From: Neil Duffield
Sent: 28 April 2021 16:24
To: Planning
Subject: NYM/2021/0049/LB E11893-21 nymnp amended scheme 28-04-21

CLIENT:	Christine Maw
PROJECT:	Barn South East of The Granary Suffield YO13 0BJ
DRAWING:	Proposed Plan and Elevations
DRAWING STATUS:	Preliminary
DRAWN:	C Eynon
CHECKED:	N I Duffield
SCALE @ SIZE:	1:100&1:50 @ A1
DATE:	05/10/20
DRAWING No:	D11893-03
REV:	D

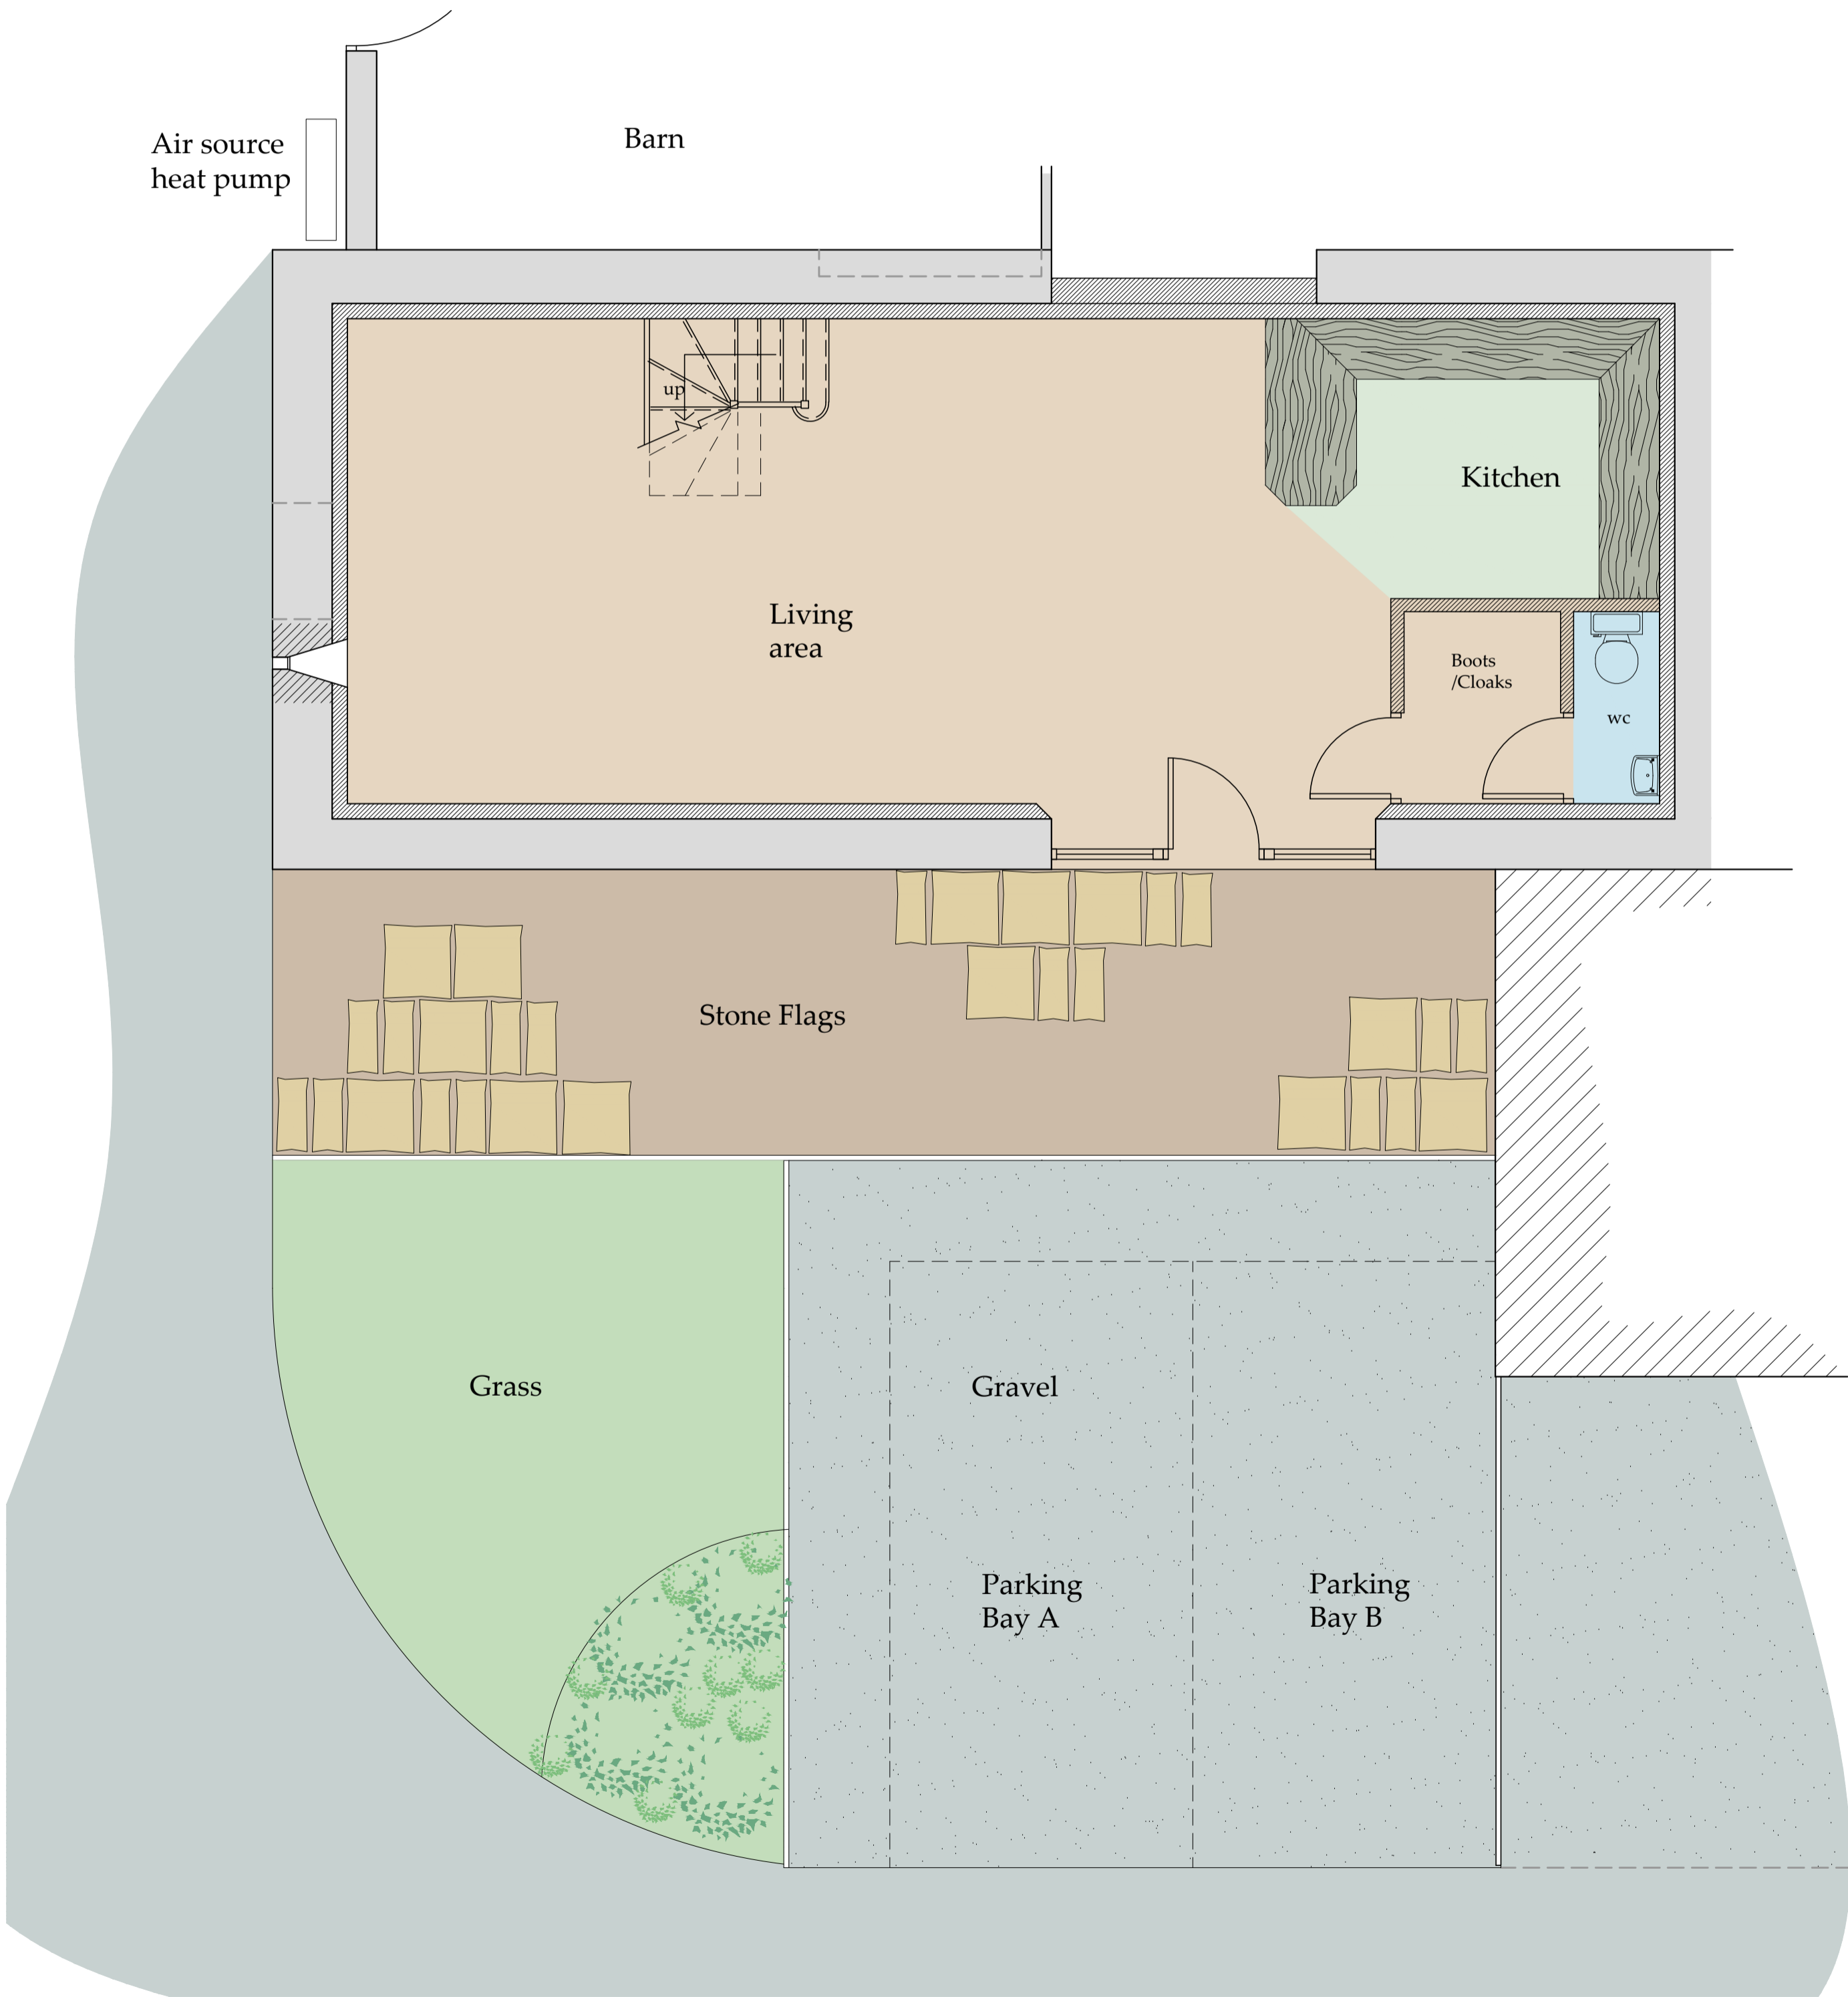
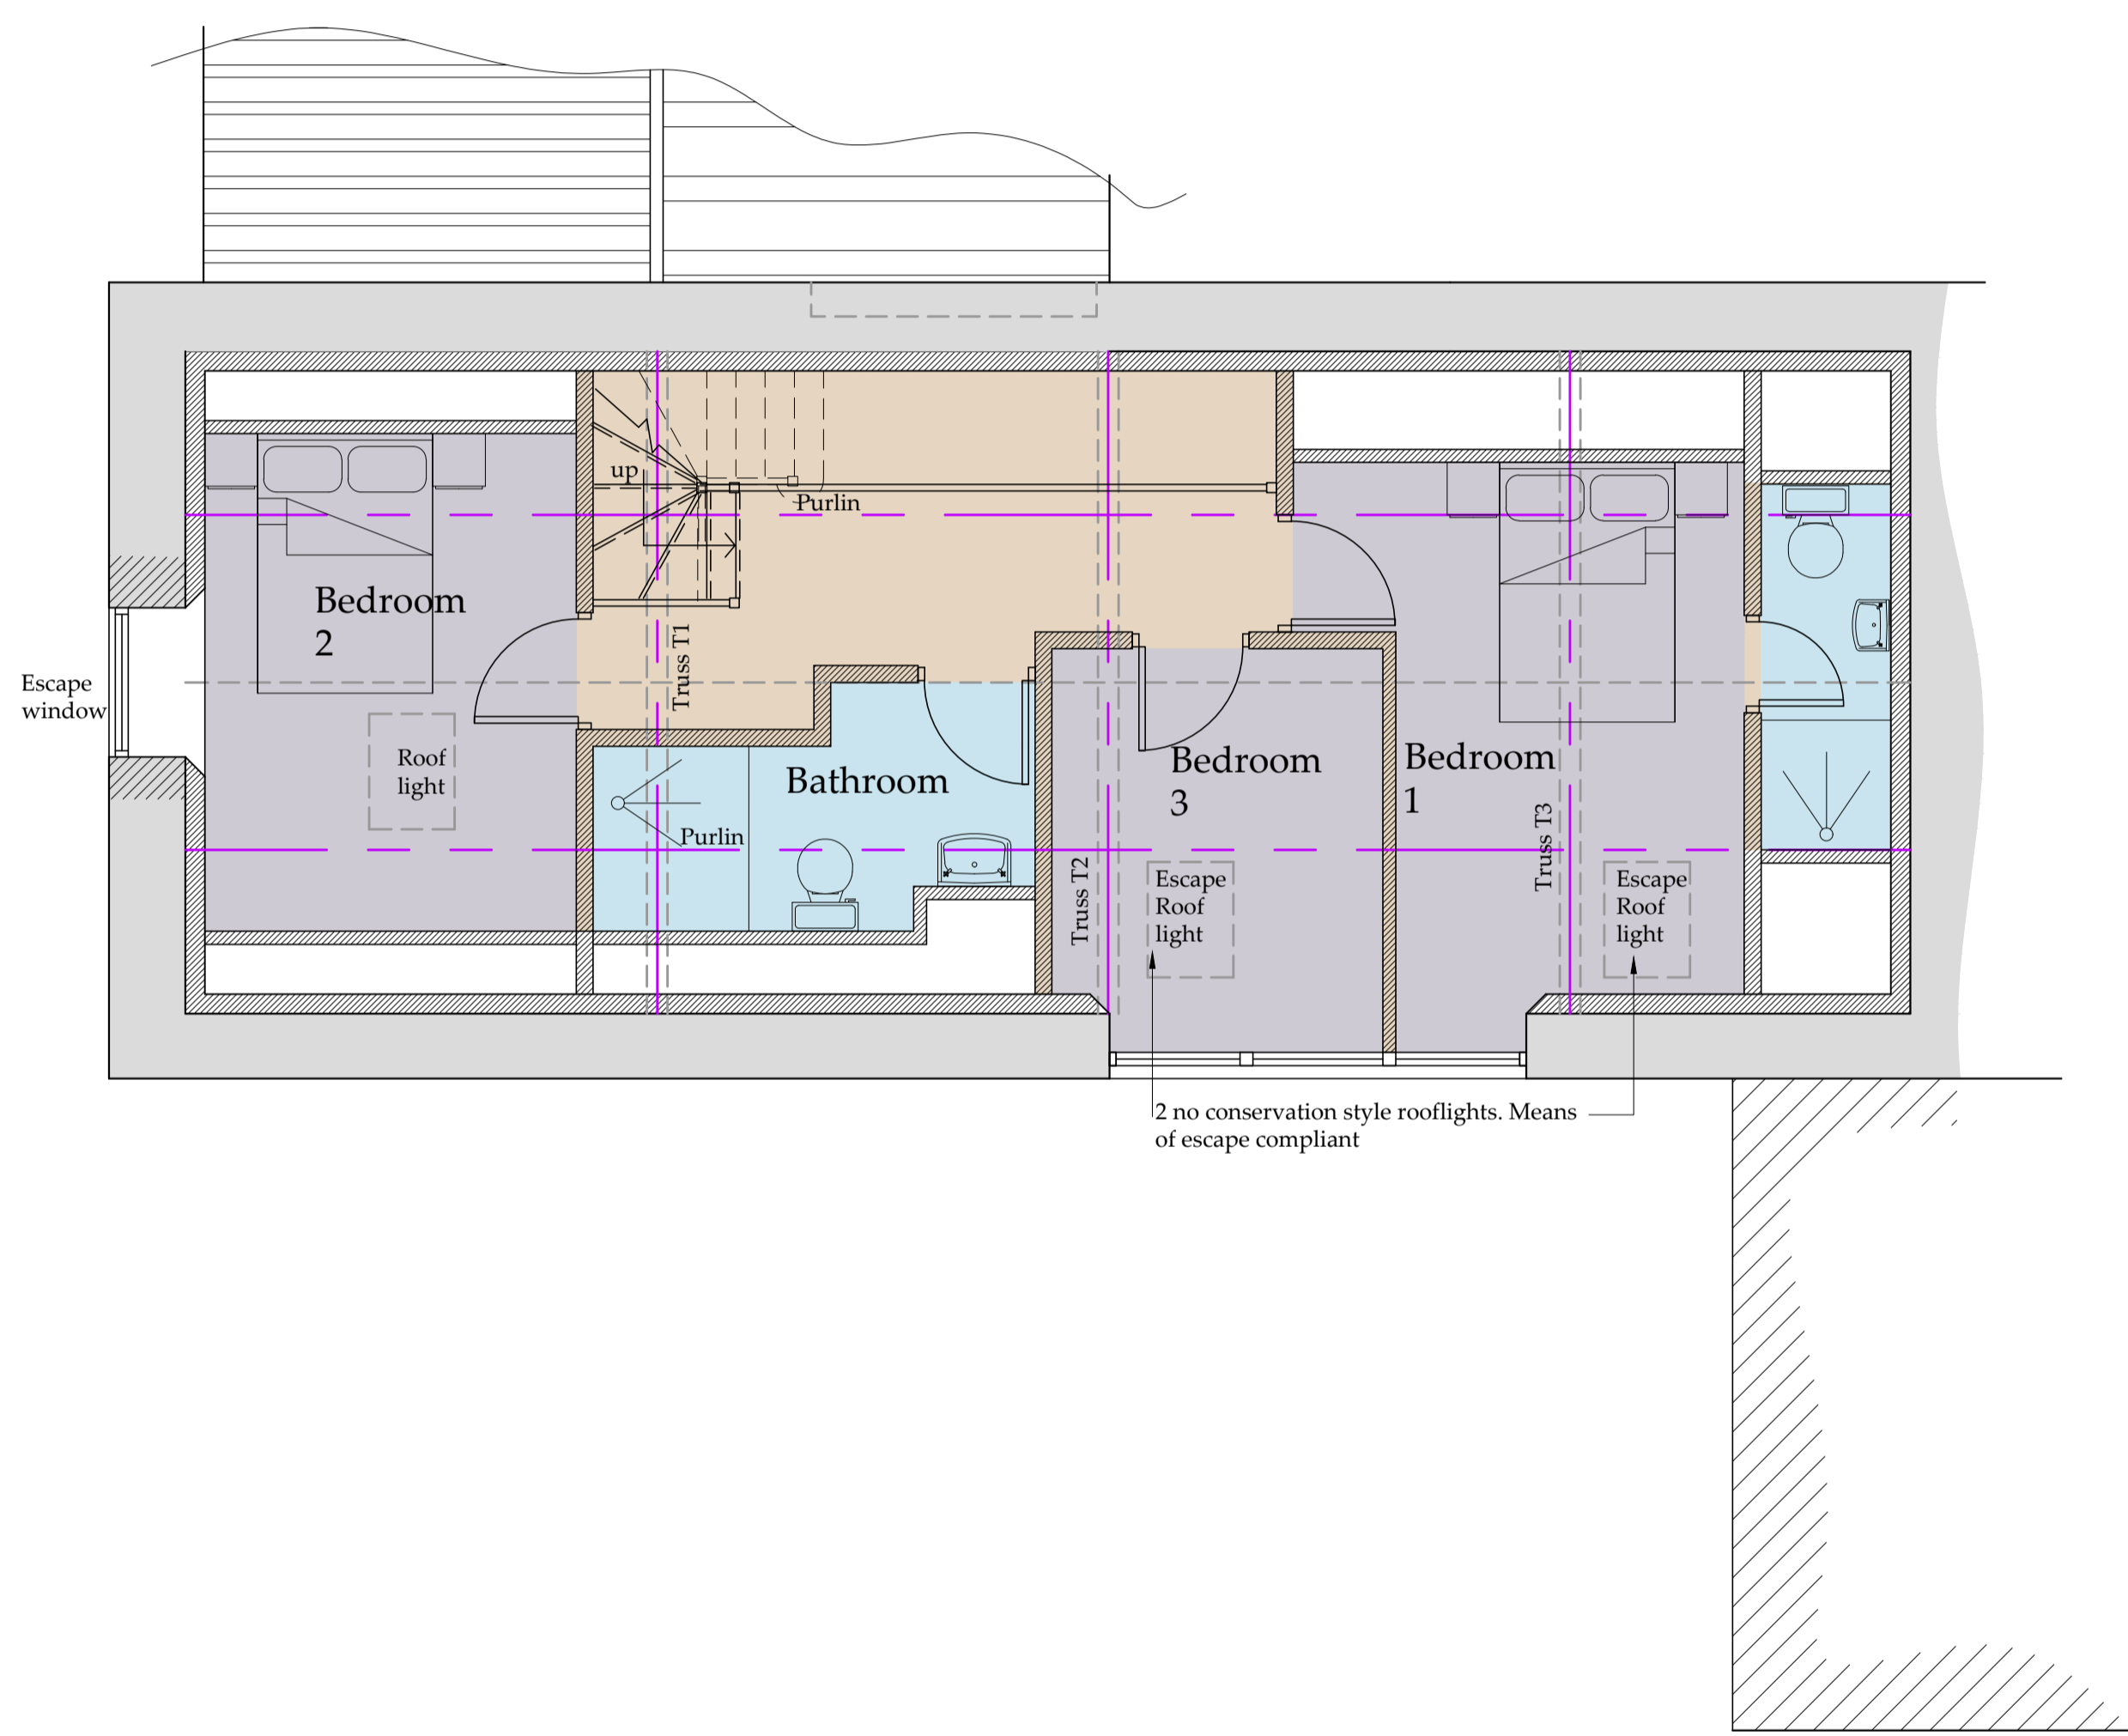
- 3 Rooflights to the front
- Pole Barn removed
- No new window openings
- Reuse 1st floor previous opening to gable.
- 3 Bedrooms to the 1st floor
- Air Source Heat Pump added to adjacent alcove
